POST TENDER ADDENDUM

JLG 16098 Bottineau Ridge II Apts

RE: post tender addendum 02

Issued: March 16, 2018

2B G106 FOUNDATION WALL TYPE FDN-2
SCALE: 1 1/2" = 1'-0"

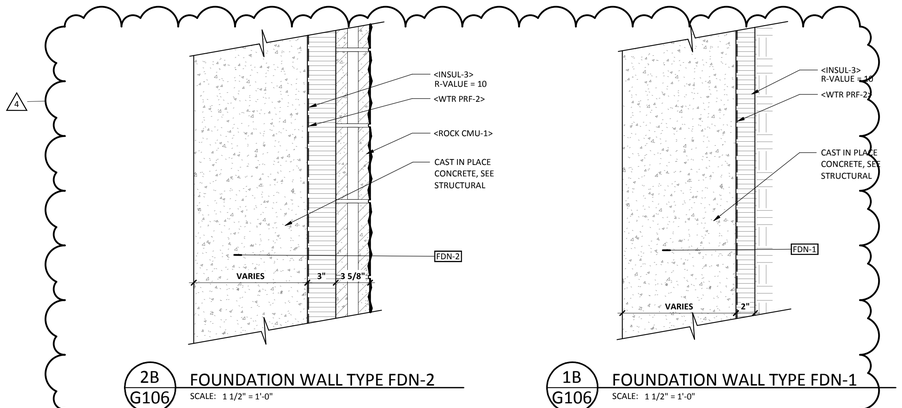
1. G100 COVER SHEET – See attachment.
    - Index of Drawings, revised Sheet C-1 to "Preliminary Plat Signature Page", and Sheet C-3 to "Preliminary Plat"
2. G106 TYPICAL ASSEMBLIES – See attachment.
    - Details 1B, 2B & 2C/G106, revised wall types to concrete in lieu of CMU.
3. C301 GRADING PLAN – See attachment.
    - Revise "PROPOSED LANDSCAPE BLOCK WALL (SEE STRUCTURAL)" to "PROPOSED LANDSCAPE BLOCK WALL (DESIGN/BUILD BY CONTRACTOR)".
    - Changed Spot Elevations near Parking Garage Entrance and on Entrance Road
4. C401 UTILIITY PLAN – See attachment.
    - Removed Catch Basin 8.
    - Moved Catch Basin 5 to the east.
    - Changed Rim and Invert Elevations of Catch Basin 5, 6, and 7.
    - Rerouted Entire Watermain.

DATE 12/04/2017
PHASE 100% CDs
PROJECT 16098
SHEET **C301**
GRADING PLAN

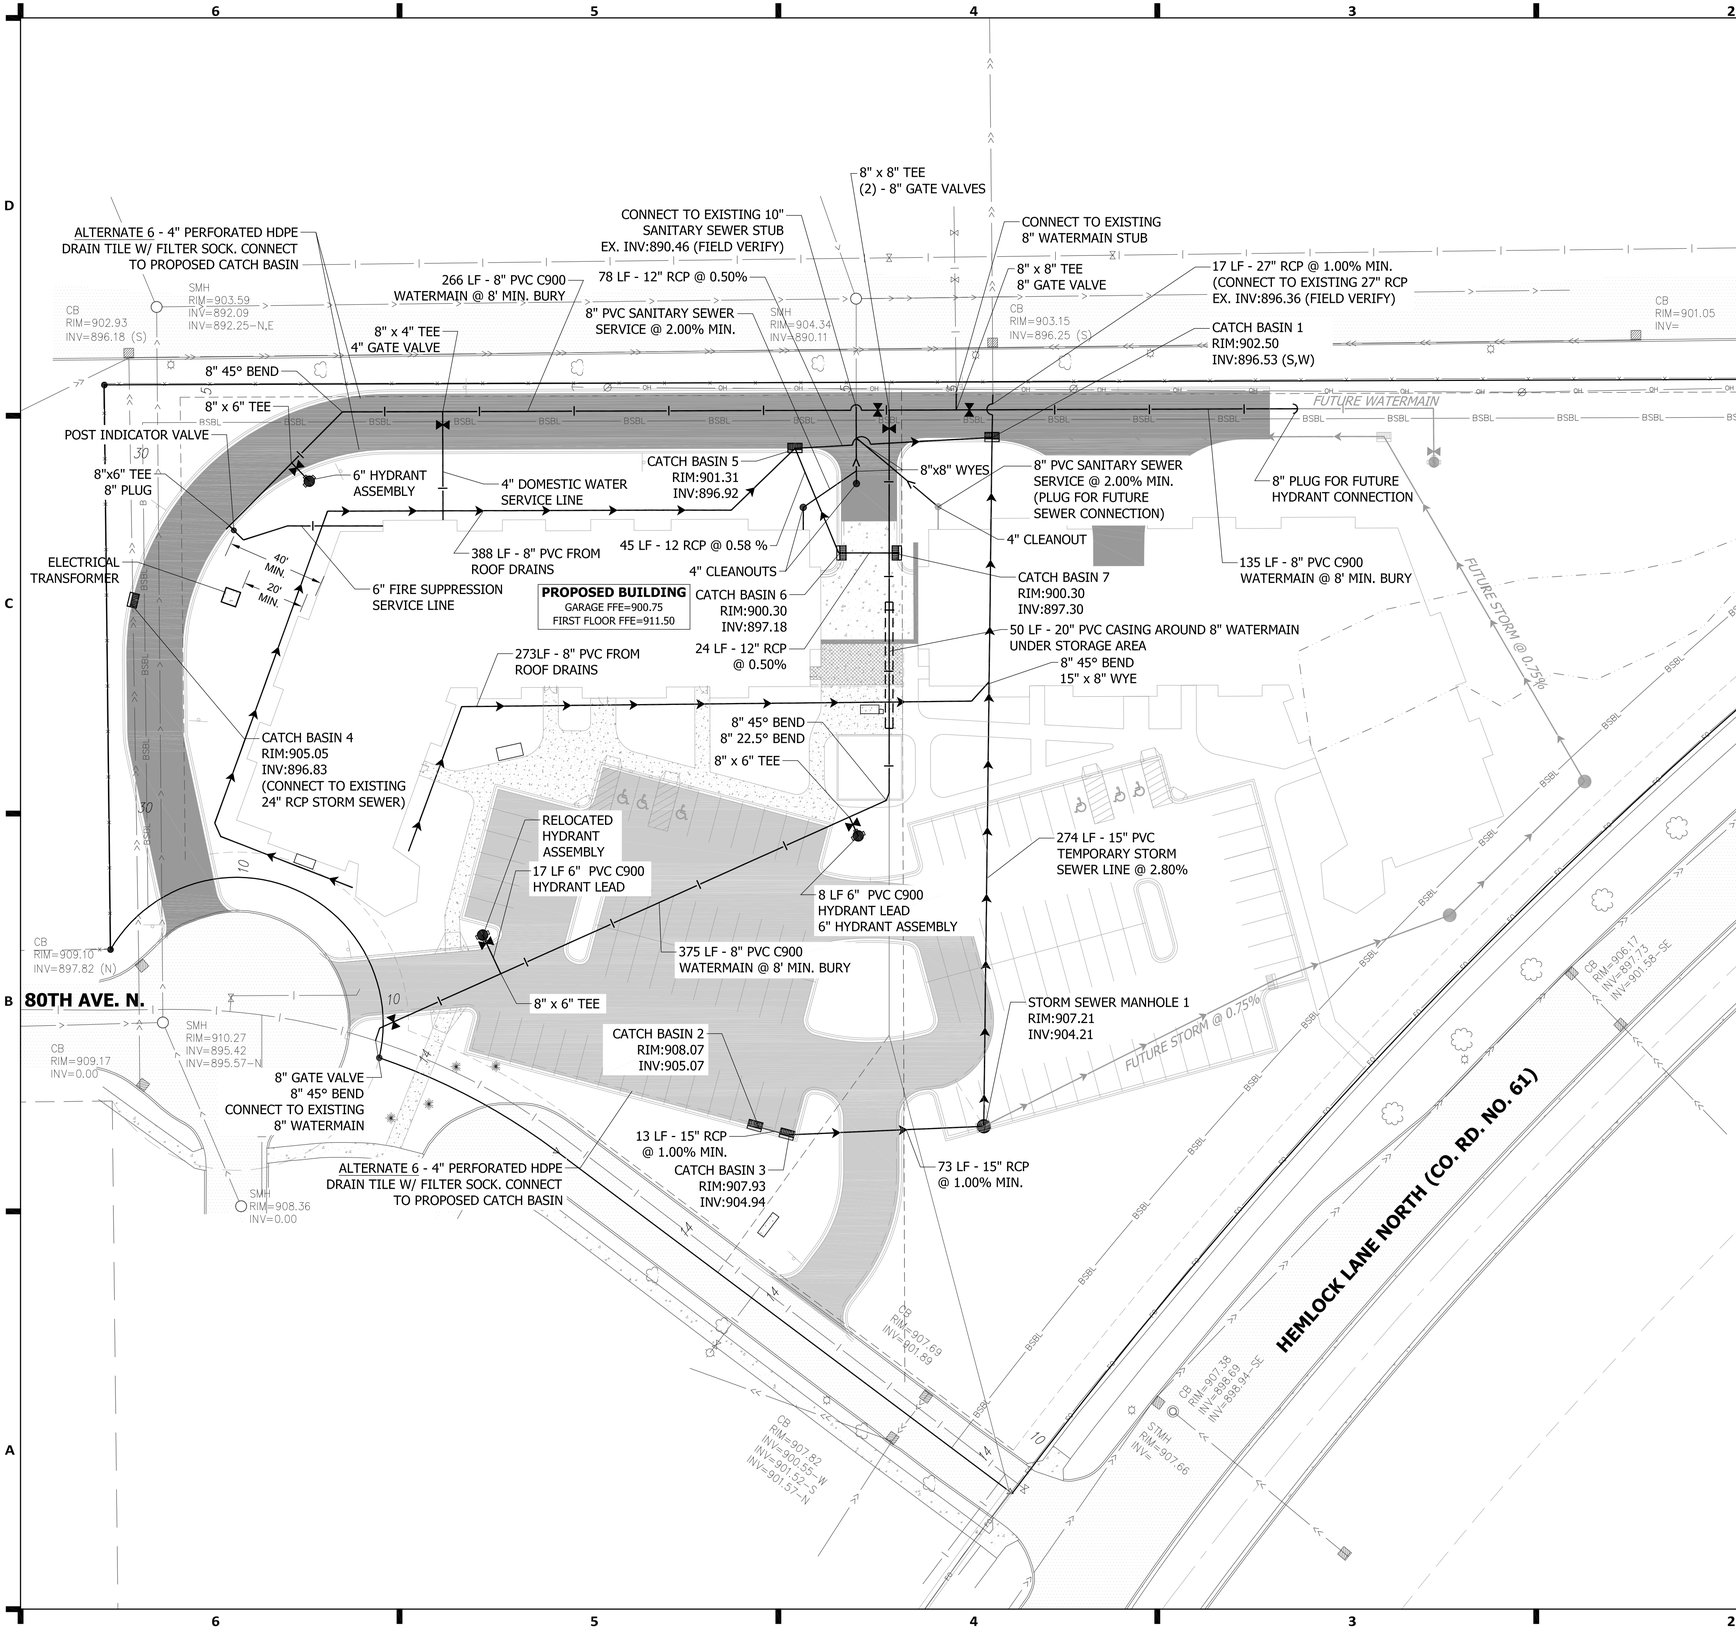
- Added 50 LF – 20" Casing for Watermain Underneath Storage Area.

DATE 12/04/2017
PHASE 100% CDs
PROJECT 16098
SHEET **C501**
EROSION CONTROL PLAN

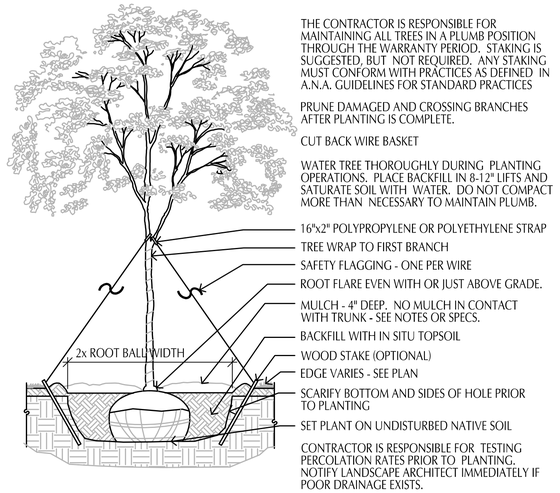
5. C501 EROSION CONTROL PLAN – See attachment.
    - Updated Inlet Protection Locations and Quantities.
6. C601 CIVIL DETAILS
    - Pedestrian Curb Ramp Standard Plate, On the Diagonal and Parrallel Ramp Details, revise the S to F to indicate slope shall be greater than 2% and less than 5% in the direction shown and cross slope shall not exceed 2%.

DATE 12/04/17
PHASE 100% CDs
PROJECT 16098
SHEET S002
SPECIAL INSPECTIONS

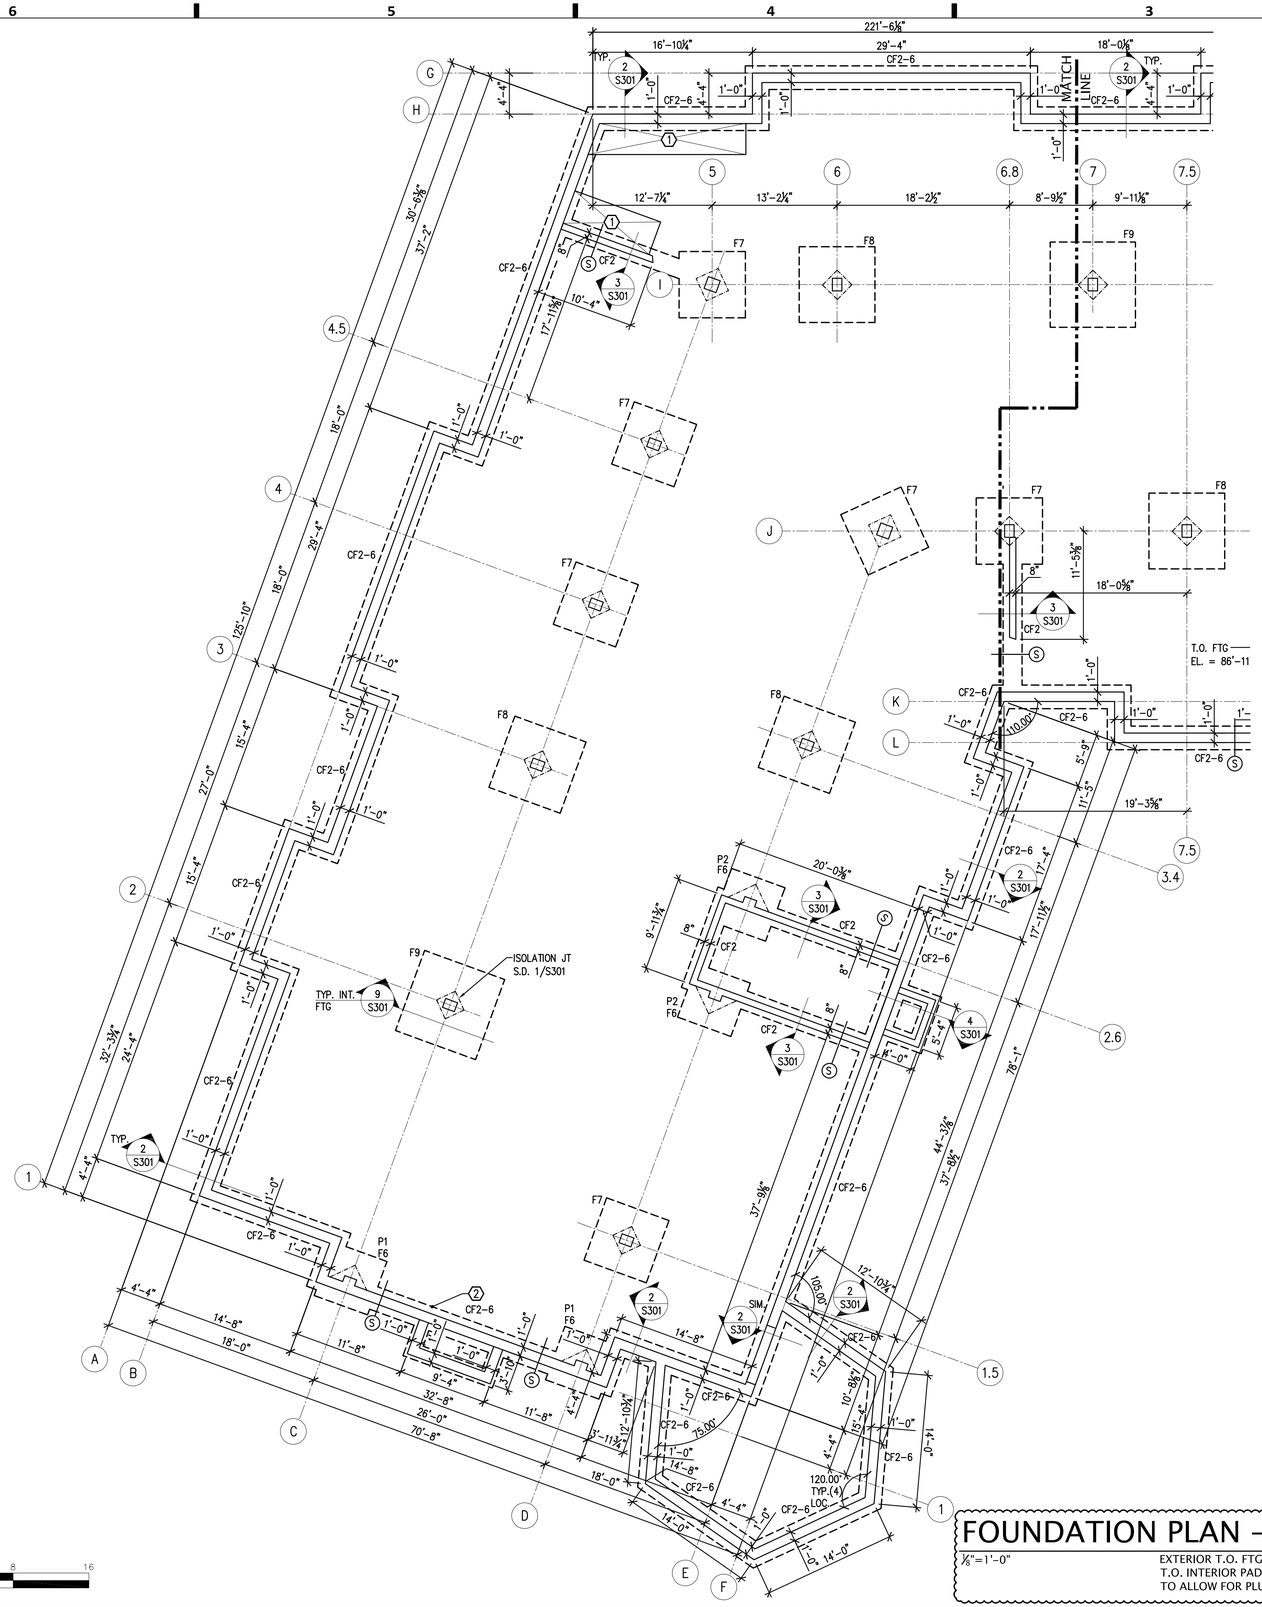
- Omitted Special Inspection table for "Masonry Level 1 Inspection." Masonry is no longer a structural component on the project and does not require inspection per the IBC, Chapter 17.

SHEET
S101B

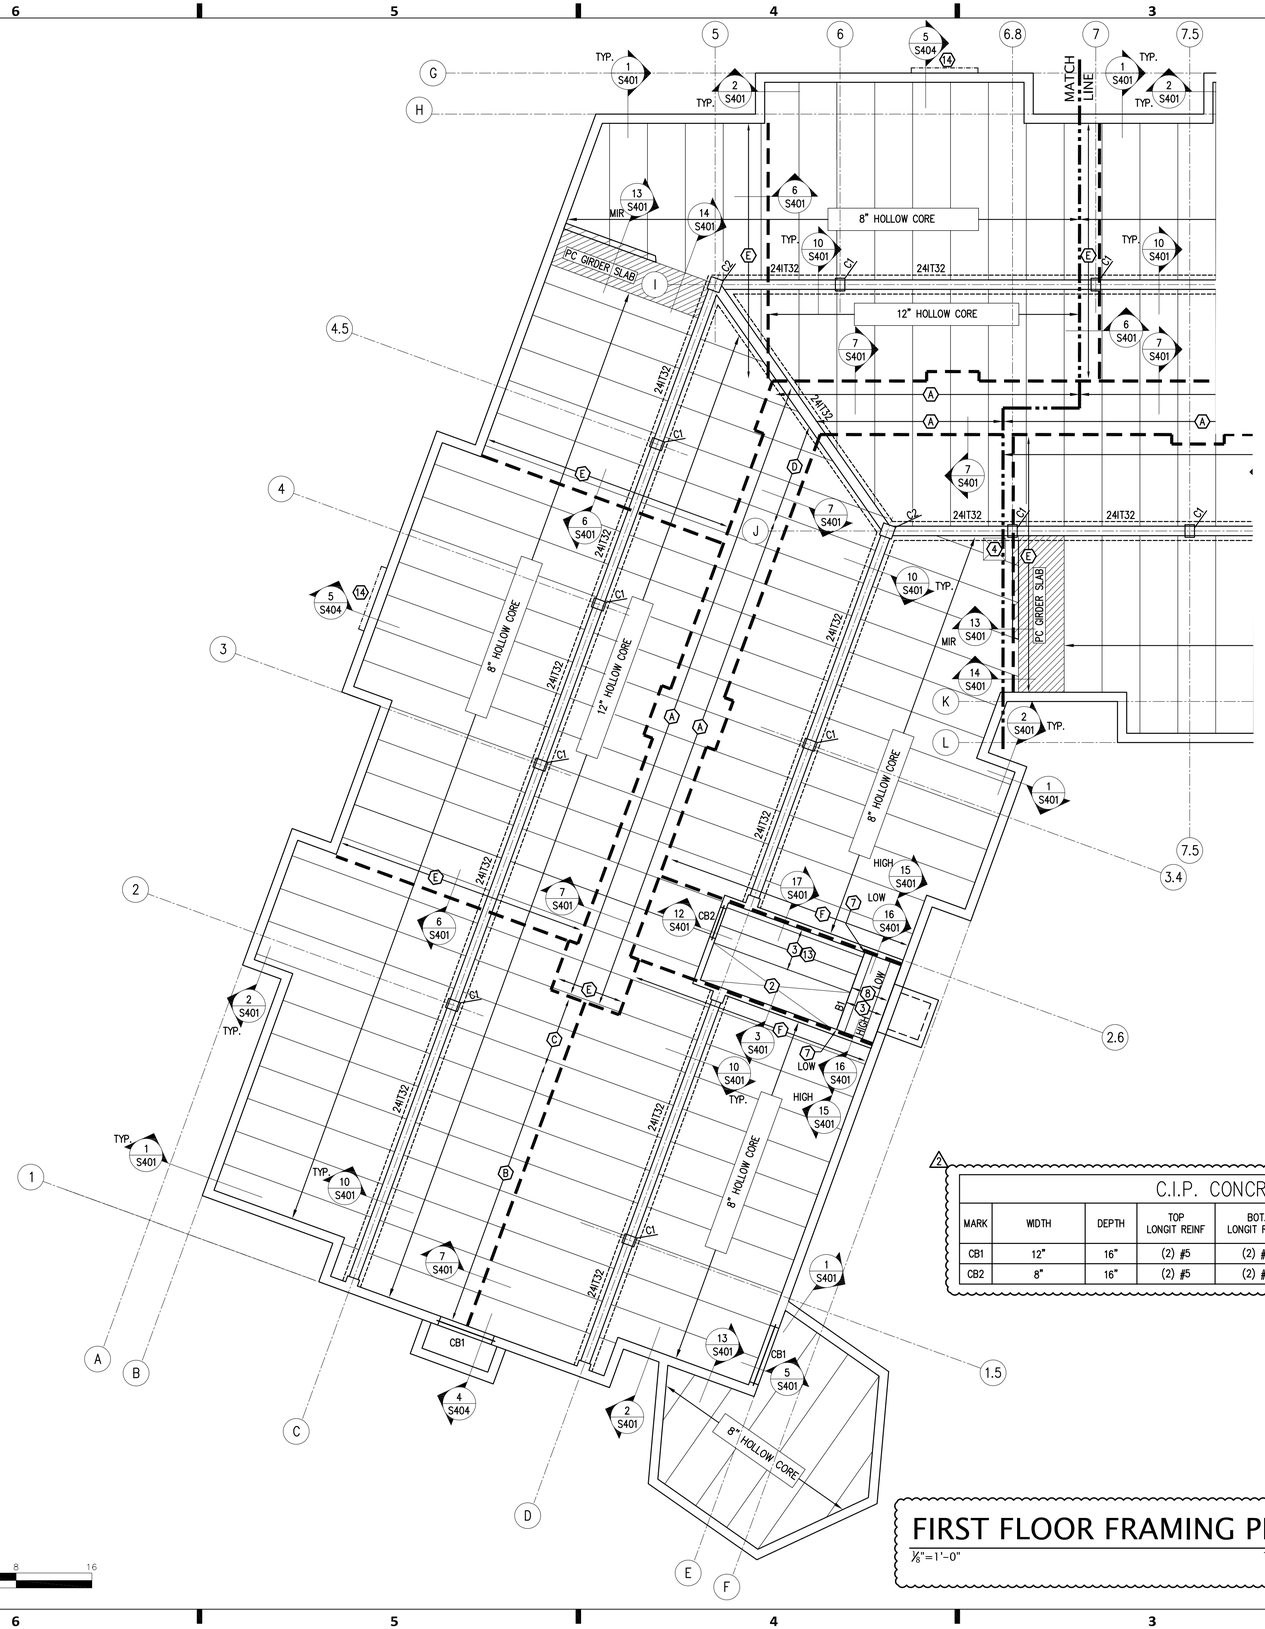
9. S101A & S101B FOUNDATION PLAN "WEST" AND "EAST" – See attachment.
    - All foundation walls and shaft walls were changed from CMU to CIP Concrete
    - CIP piers at precast beam bearing were updated

SHEET
S201A
FIRST FLOOR FRAMING PLAN "WEST"

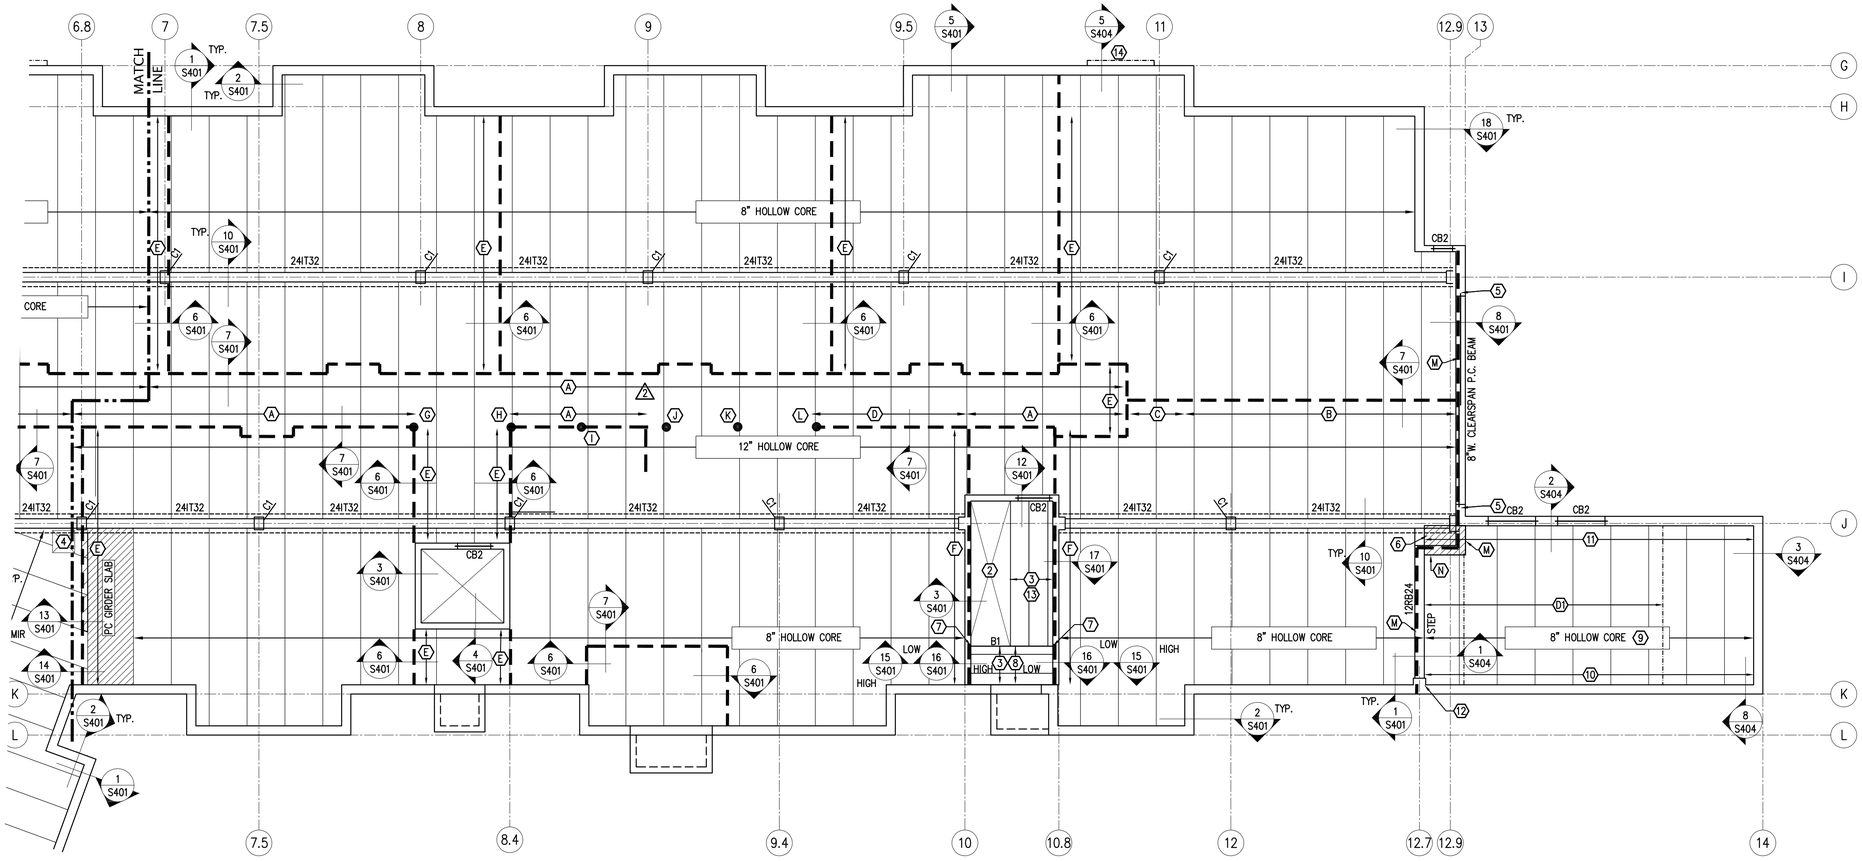
10. S201A & S201B FIRST FLOOR FRAMING PLAN "WEST" AND "EAST" – See attachment.
    - All foundation walls and shaft walls were changed from CMU to CIP Concrete

- Precast columns were eliminated alongside CIP walls and replaced with CIP piers
    - New foundation wall dimensions at the NE corner of the building where grade drops

- CMU lintels were replaced with CIP concrete beams
    - Reinforcement was updated and added for CIP foundation and shaft walls
11. S206 SHEAR WALL PLAN AND DETAILS – See attachment.

SHEET
S401
FRAMING DETAILS

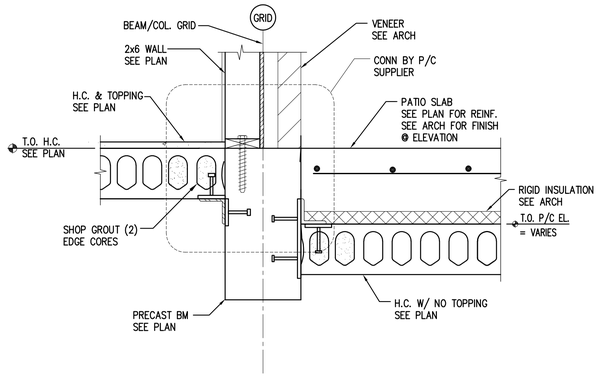
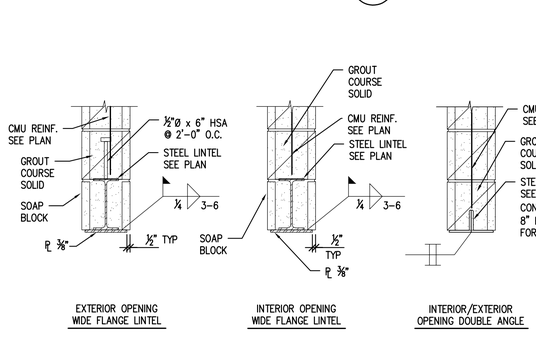
- Details updated for CIP foundation walls
14. S401 FRAMING DETAILS – See attachment.
    - Details updated for CIP foundation walls
15. S404 FRAMING DETAILS – See attachment.
